Memorandum

SUBJECT: **LAKES OF FAIRVIEW**

BACKGROUND: This is a request for approval to rezone 64.03-acres of land to the (PC) Planned Center District with modified (RE-1) One-acre Ranch Estates District design standards. The site is generally located east of Stoddard Road, between Country Club Road and Hart Road and is zoned for the (RE-3) Three-acre Ranch Estate District, (RE-1) One-acre Ranch Estate District and (PC) Planned Center District for the Fairview Country Day School. Applicant: Stephen DiNapoli, DiNapoli Development, LLC representing Shannon and Robert Kelly, Diane and Michael Pezzulli and Mark and Morgan Stoddard. (ZA2017-01)

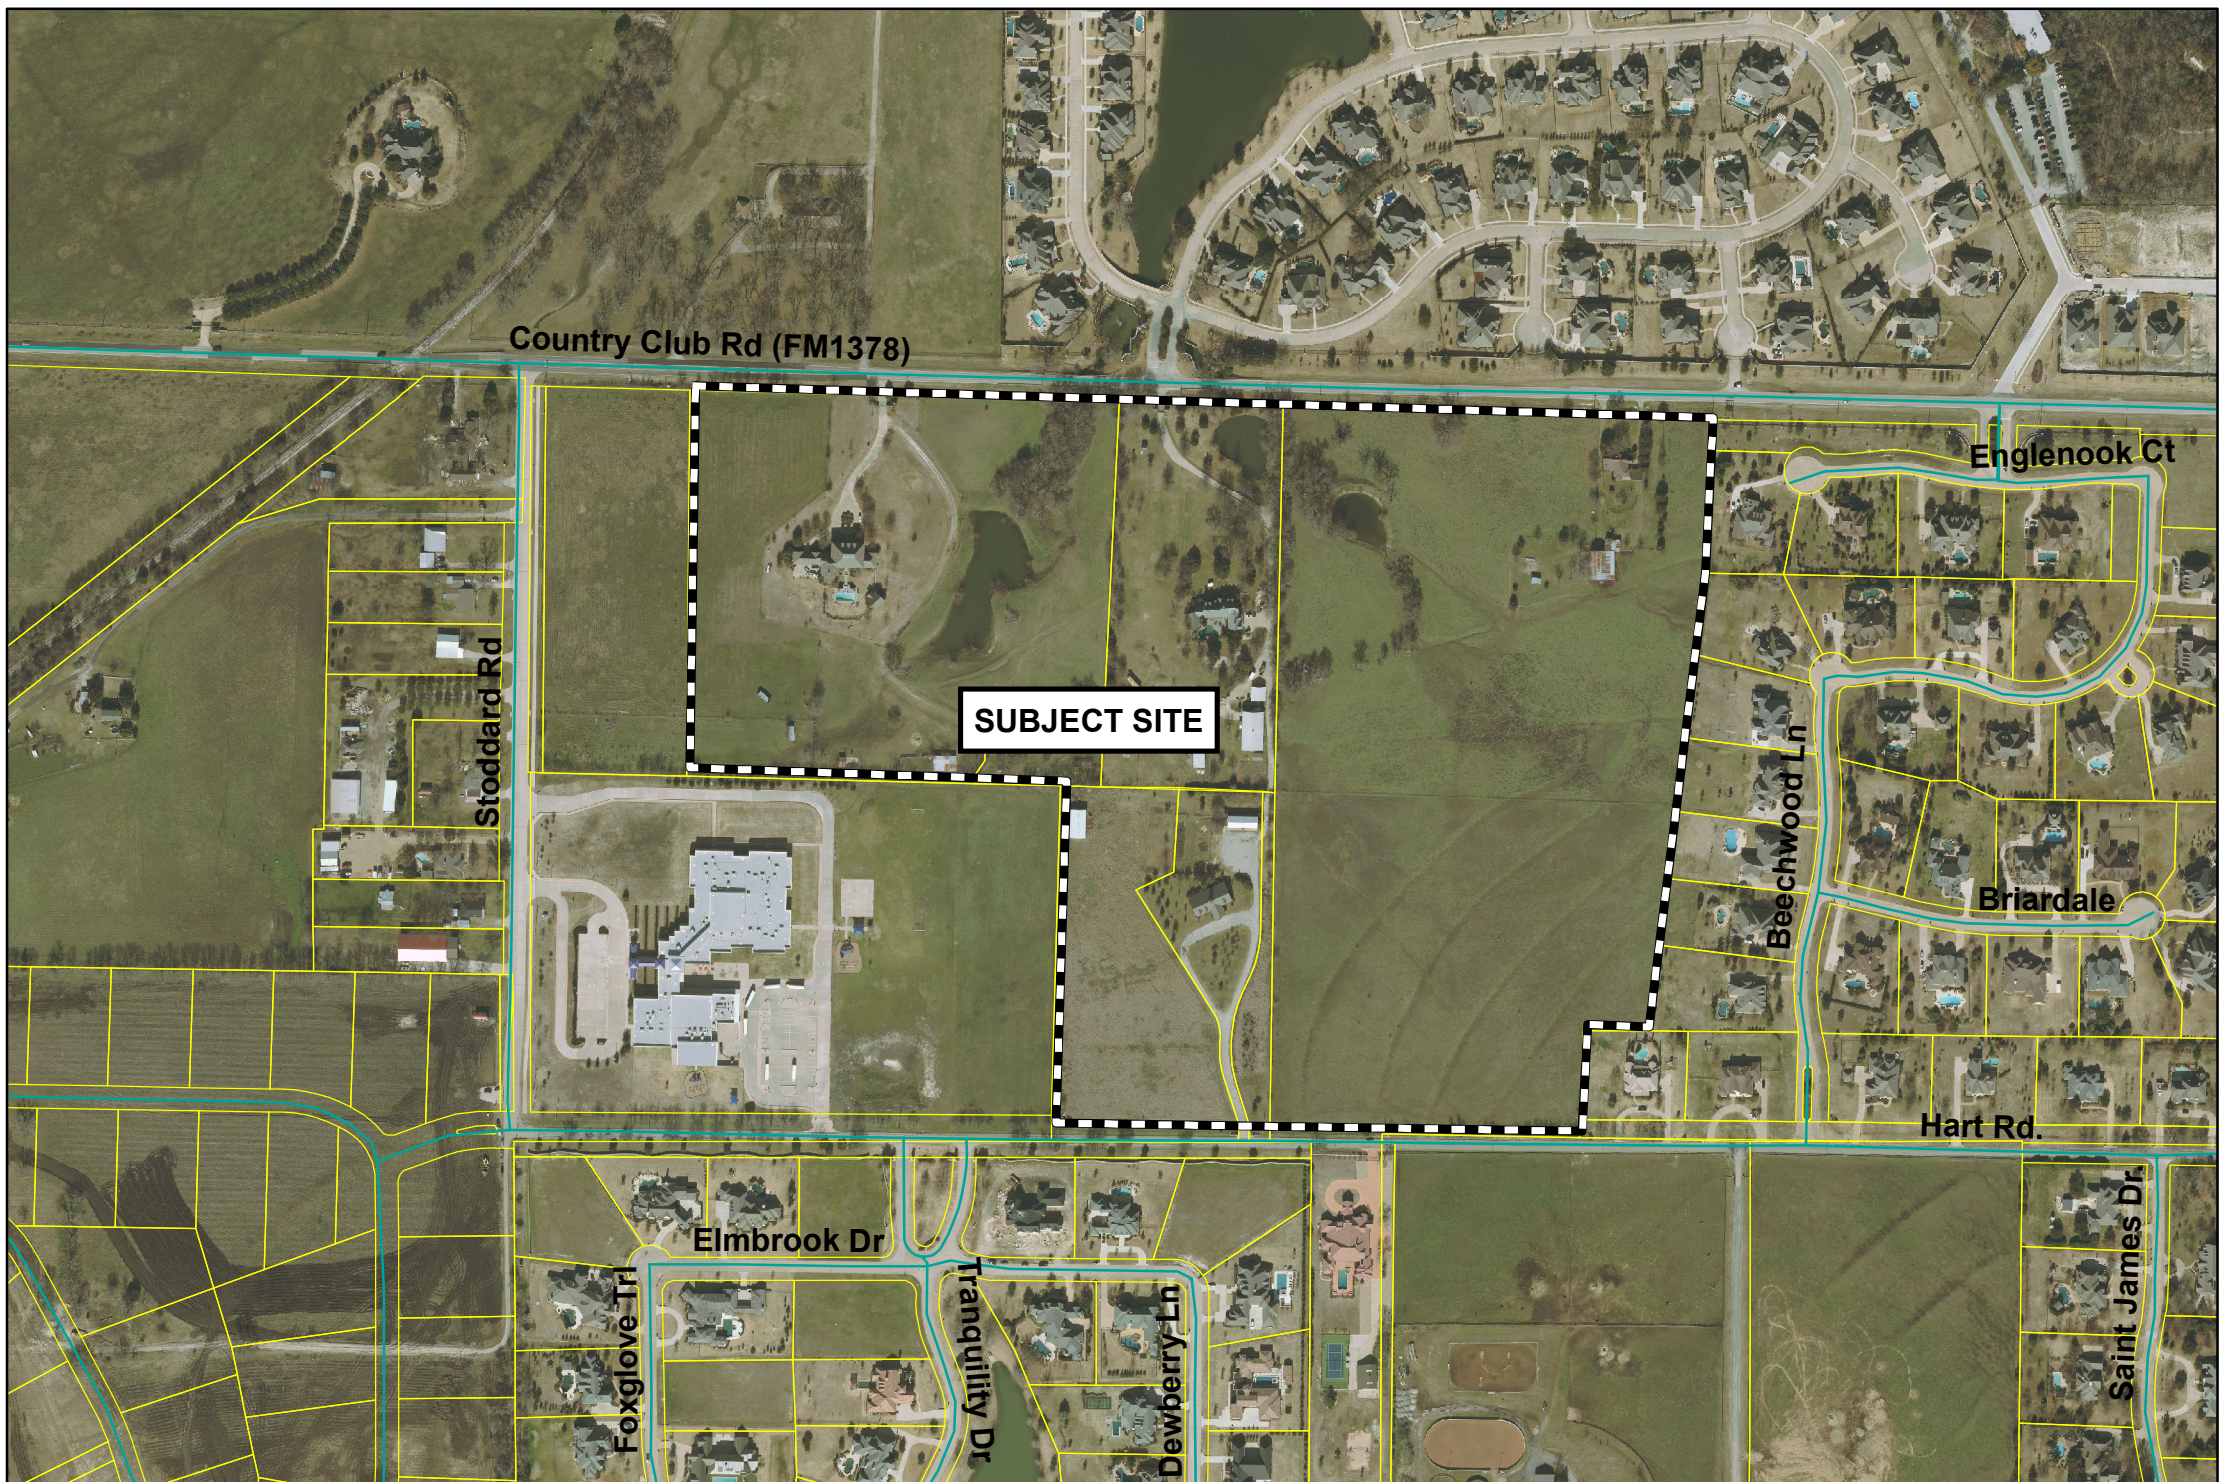
As proposed, the development will have two major points of access; one along Country Club Drive and one along Hart Road. Additionally, proposed Lots 37-40, will have direct driveway access to Country Club Road. Per the suggested development guidelines, driveway access to County Club Road for Lot 41 will be prohibited. Currently, each of the three (3) existing homesites have driveway access onto Country Club. One of the homes will be removed, and another will transition driveway access internal to the development, therefore, has presented, the proposal has a net increase of one (1) additional driveway onto Country Club. To prevent additional driveway along

Hart Road, Lots 11-15 must be internally accessible and will not have driveway access to Hart Road.

As reflected on the concept plan, the site borders the Fairview Meadows subdivision to the east. To buffer the proposed development from the existing neighborhood, the applicant is proposing to install a 25' wide landscape buffer along the common border. The buffer would be planted with a variety of canopy ornamental trees in accordance with the "Typical Lot Screening" exhibit attached. This landscape buffer will continue along the southern property line adjacent to Hart Road for proposed Lots 11-15. As previously noted, these lots are prohibited from having driveway access onto Hart Road, and the landscape buffer will provide screening from the adjacent roadway.

The concept plan reflects three (3) open space common areas totaling 7.5-acres. Each of these lots will contain water features, two of which maintain an existing pond. Included within the open space and adjacent to Country Club Drive is a 50' wide landscape area. As reflected on the concept plan, the buffer area will feature a man-made stream that feeds the downstream pond.

1. Zoning: (PC) Planned Center District for the (RE-1) One-Acre Ranch Estate District with the following modifications:
 - a. Maximum Lot coverage: 40%
2. Site shall generally be developed in accordance with the concept plans. All structures and uses on Lots 29 and 39, as shown on the concept plan, existing on the date of adoption of this (PC) district, shall be permitted uses.

3. Maximum density shall be 42 residential lots.
4. 10' wide concrete trail shall be installed along Hart Road.
5. A 25' wide landscape buffer shall be installed along the common property line adjacent to the Fairview Meadows Addition (Lots 4-11), and southern property line adjacent to Hart Road (Lots 11-15). Said buffer shall be planted generally in accordance with the "Typical Lot Screening" Plan. Canopy/Shade Trees shall be a minimum of 3-inch caliper and 12-feet tall at the time of planting. Ornamental and multi-stem trees shall be a minimum of 3-inch caliper, and/or have a minimum of 3 canes for multi-stem trees, and be a minimum of 8-feet tall in height at the time of planting.

7. A cul-de-sac longer than 600 feet in length shall be permitted, however, homes constructed on Lots 33-36 shall install a fire suppression sprinkler system.

8. Lot 41 shall not have driveway access to Country Club Road.
9. Lots 11-15 shall face internal to the development, and will not have driveway access to Hart Road.
